Contractor UPDATE

Revised Torque Specification for BauderSOLAR G Light Mounting Clamps

Mandatory installation requirement— 18Nm

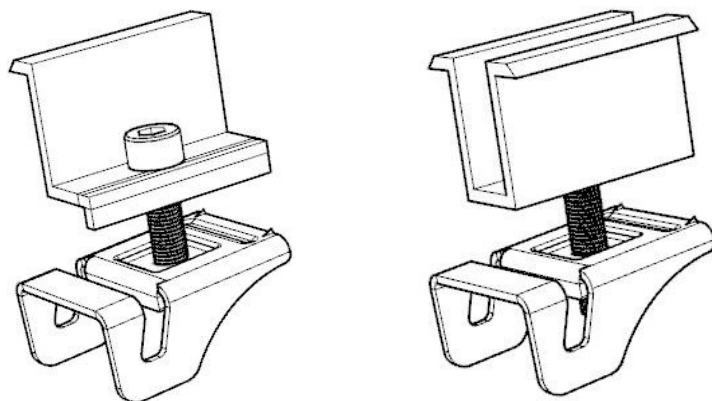
Please be advised that the torque specification for securing G Light mount panel clamps has been updated. All clamps must now be secured to **18Nm using a calibrated torque wrench**.

The torque specification has been updated to 18Nm to ensure consistent clamp security and system reliability. Recent specification reviews identified that the torque setting increasing to 18Nm improves force under condition such as thermal expansion, wind uplift and vibration. By standardizing 18Nm:

- Update installation procedures
- Ensure all site teams are informed and equipped with calibrated torque wrenches.
- Confirm compliance during all future installations.
